Supplementary Statement

**Proposed Temporary Open Storage of Construction Materials and
Machinery and Associated Filling of Land for a Period of 3 Years
in "Agriculture" Zone, Lots 968 (Part), 969 (Part), 970 (Part), 971 (Part),
972, 973, 975, 976, 977 and 978 RP in D.D. 82, Ping Che, Ta Kwu Ling
(Compliance with Approval Condition (a) for Planning Application No. A/NE-TKL/815)**

Compliance with Approval Condition (a)

Appendix I - Response to the Comments of Chief Engineer/Mainland North, Drainage Services Department (CE/MN, DSD)

PROJECT: PROPOSED TEMPORARY OPEN STORAGE OF CONSTRUCTION MATERIALS AND MACHINERY AND ASSOCIATED FILLING OF LAND FOR A PERIOD OF 3 YEARS	TITLE PROPOSED DRAINAGE SYSTEM	FIGURE NUMBER FIGURE 3		
		VER	DESCRIPTION	DATE

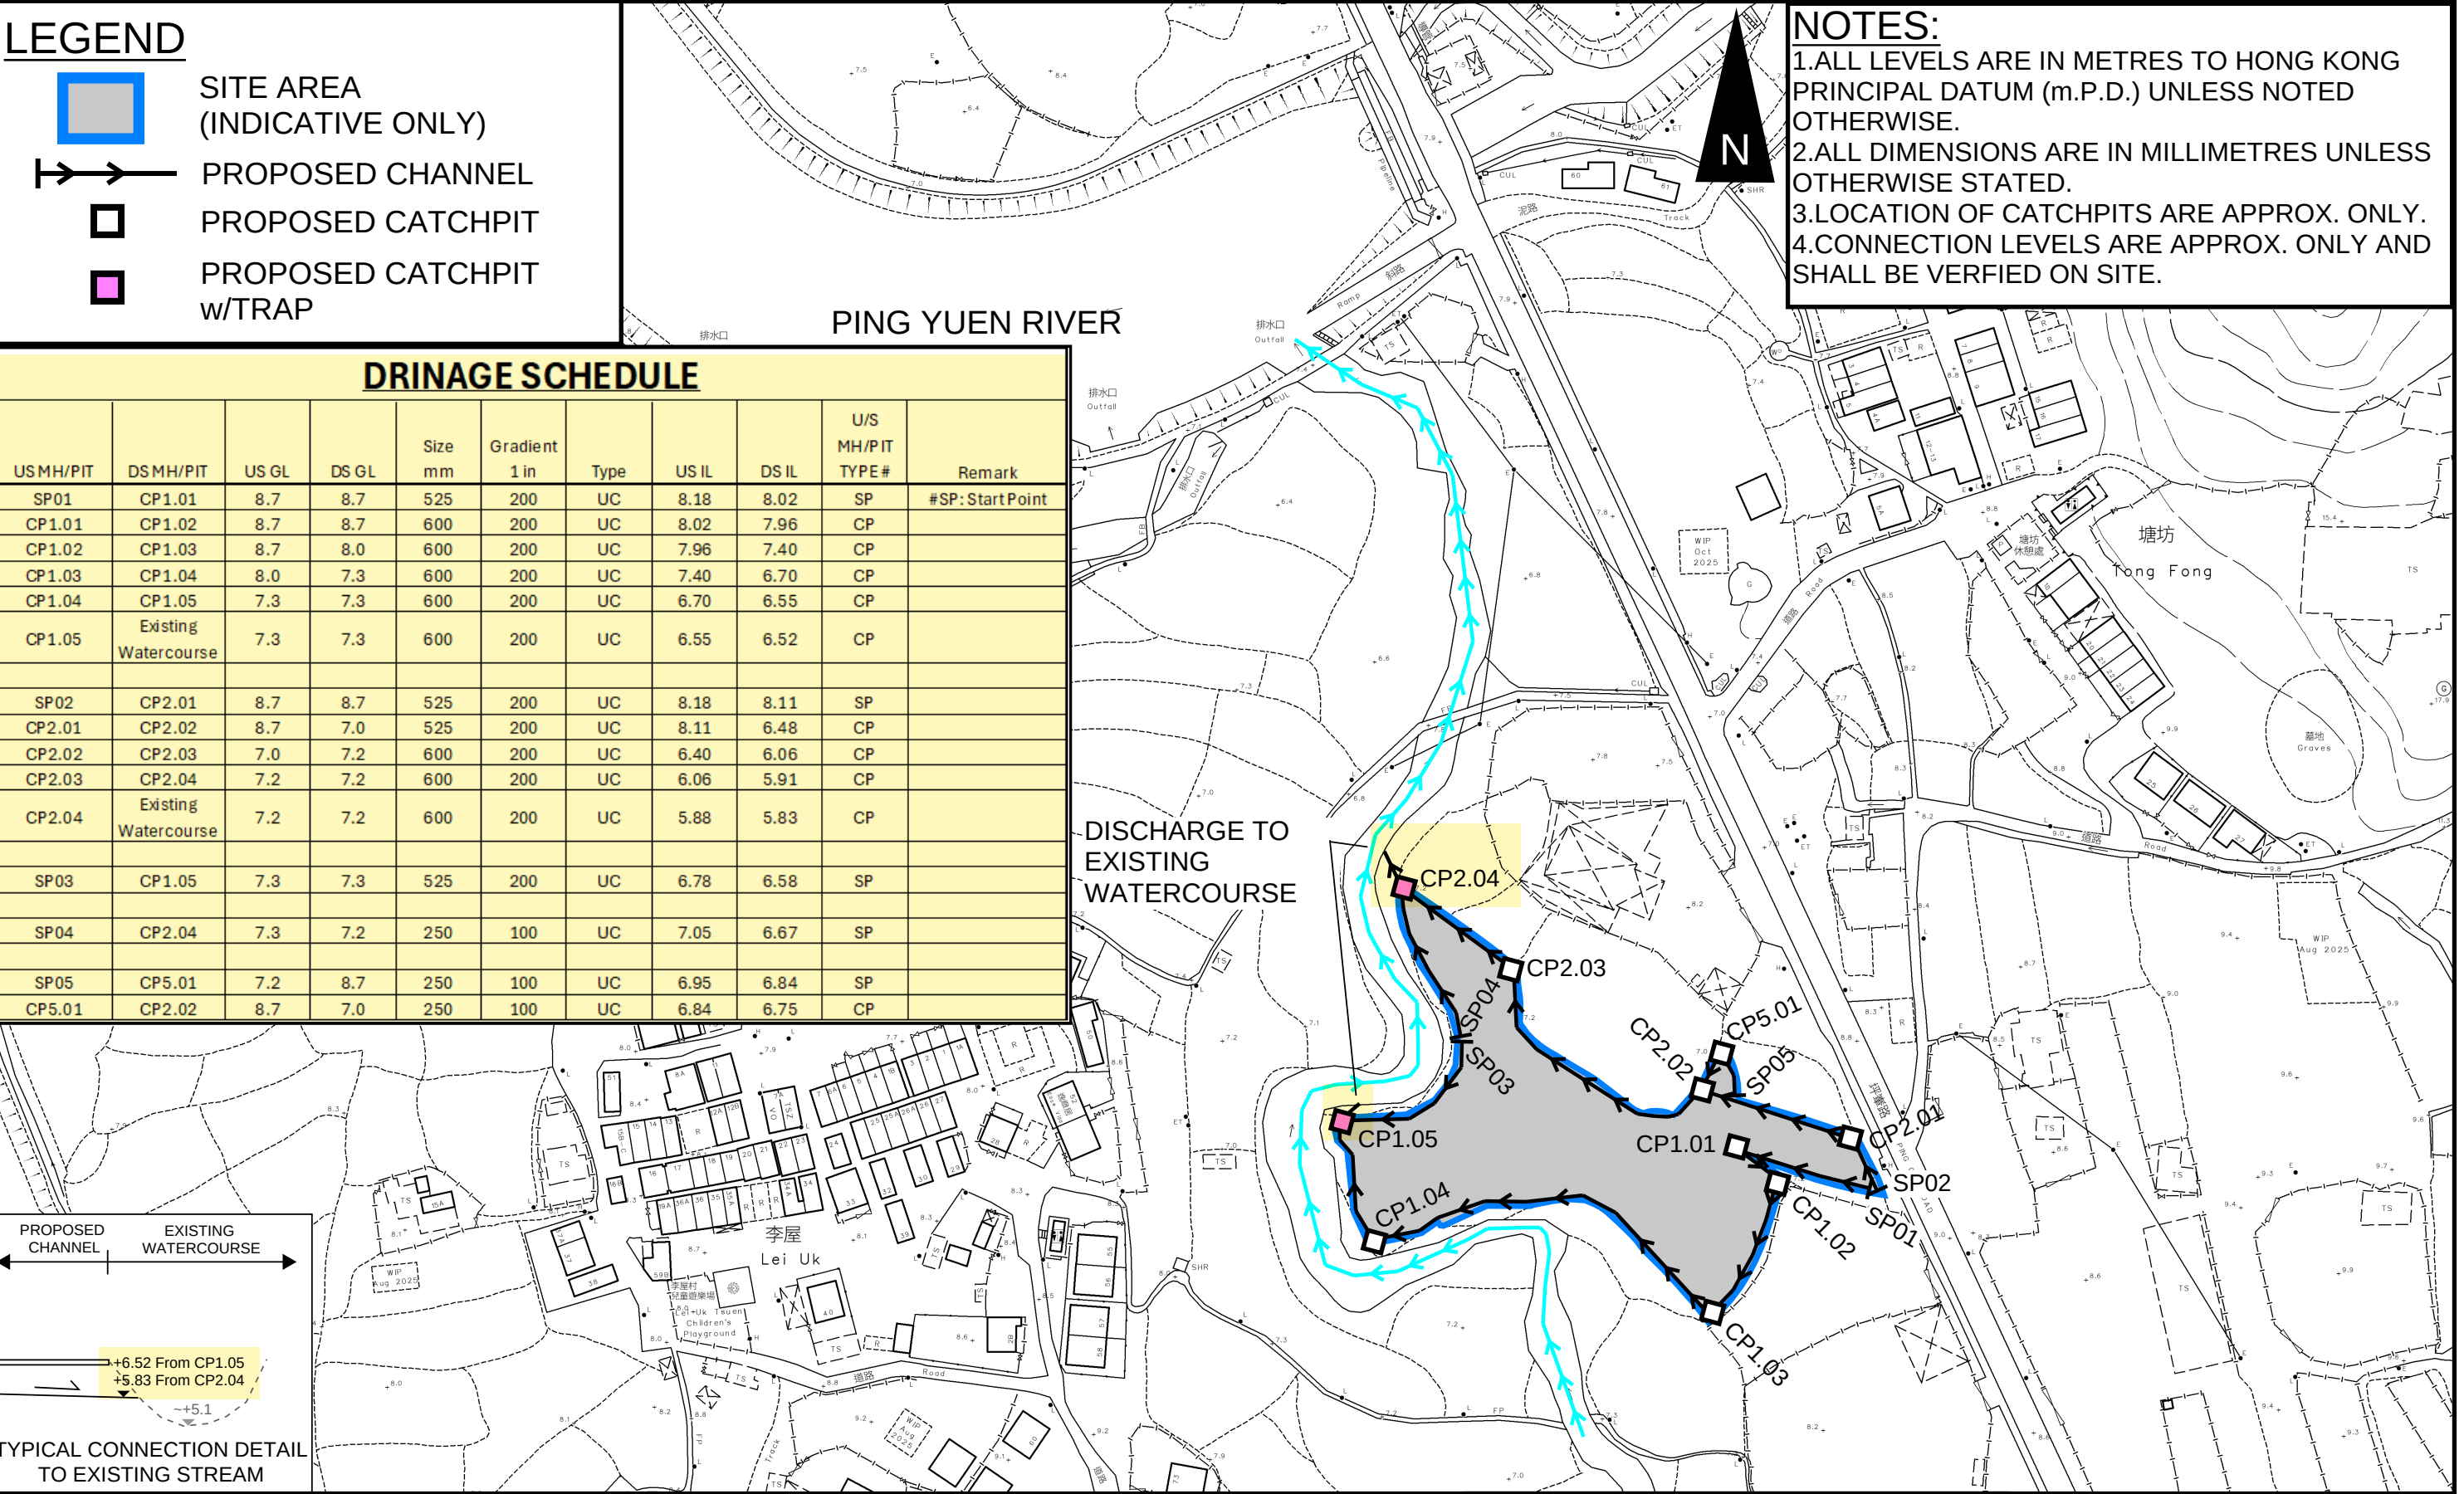
(4)	Figure 3 refers. The applicant should review if the proposed connection channels at downstream of CP1.05 and CP2.04 can be oriented to face the water flow direction of Ping Yuen River, with the view to minimising turbulence during water discharge;	Noted. The connection channel is revised for minimising turbulence (Appendix II).

PROJECT: PROPOSED TEMPORARY OPEN STORAGE OF CONSTRUCTION MATERIALS AND MACHINERY AND ASSOCIATED FILLING OF LAND FOR A PERIOD OF 3 YEARS	TITLE CATCHMENT PLAN	FIGURE NUMBER FIGURE 4		
		VER	DESCRIPTION	DATE

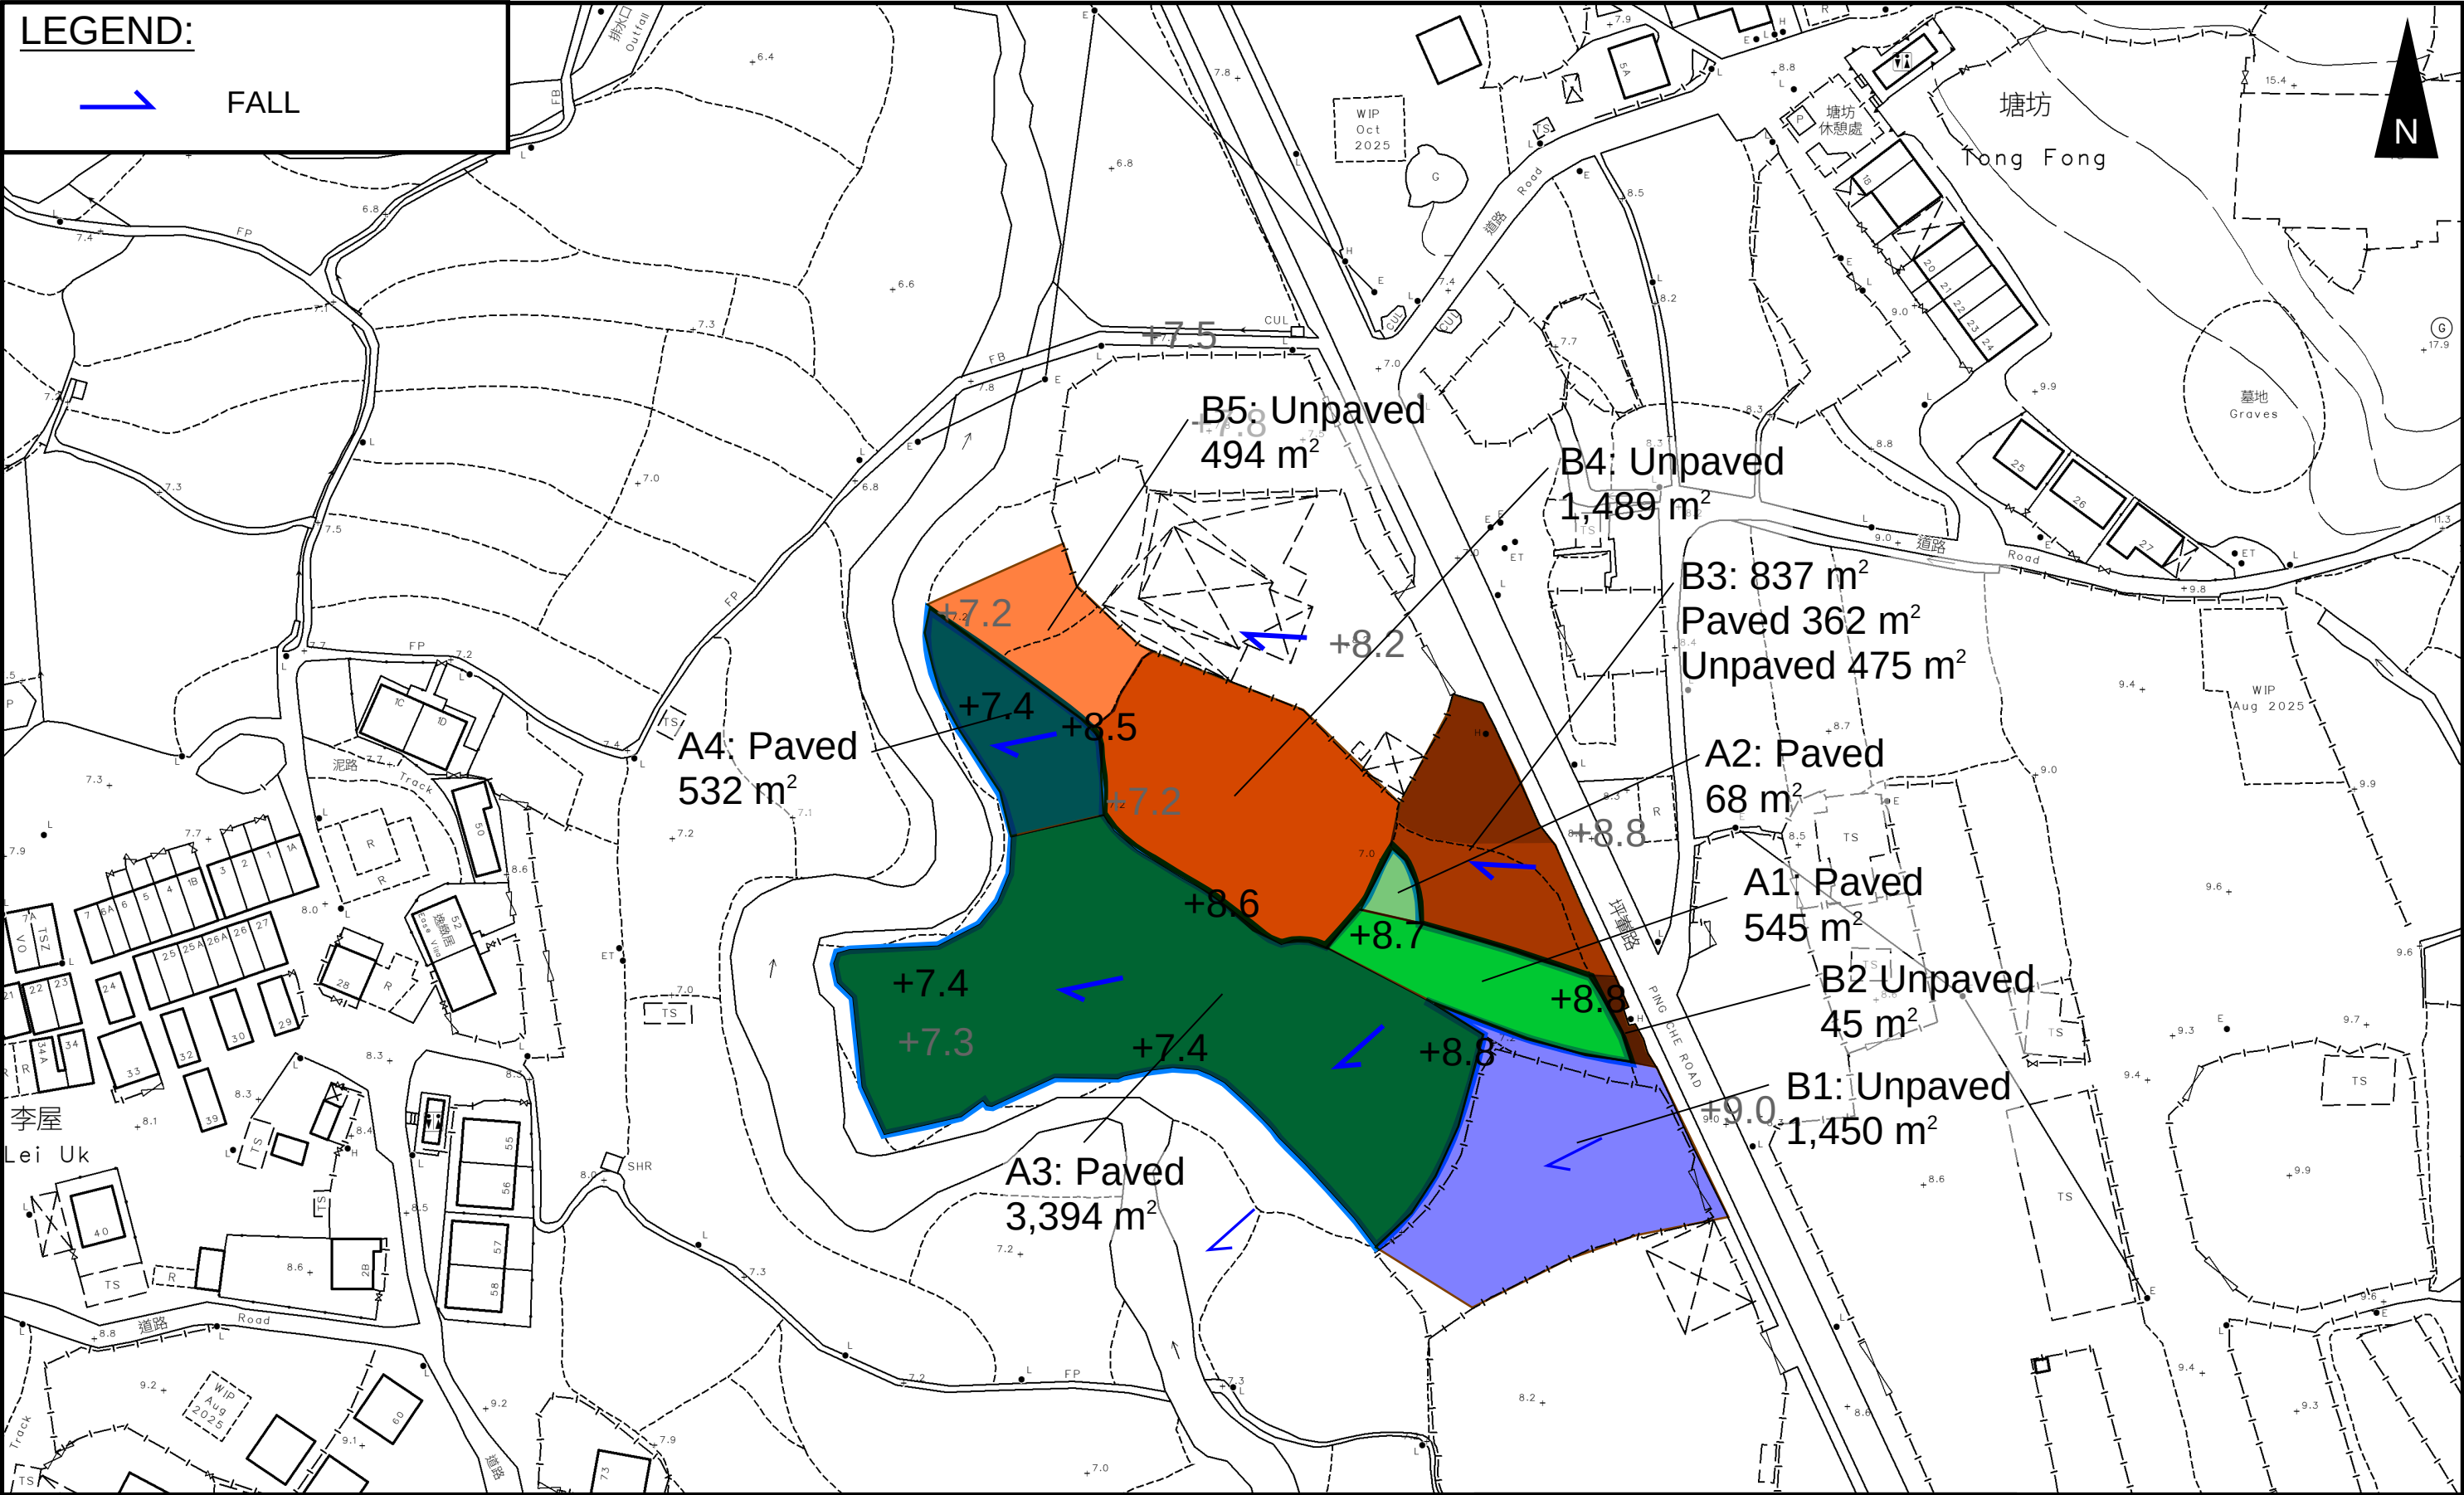
(5)	Figure 4 refers. The applicant should provide future spot levels to justify the indicated flow path;	Noted. Please find updated Figure 4 in Appendix II for your perusal.
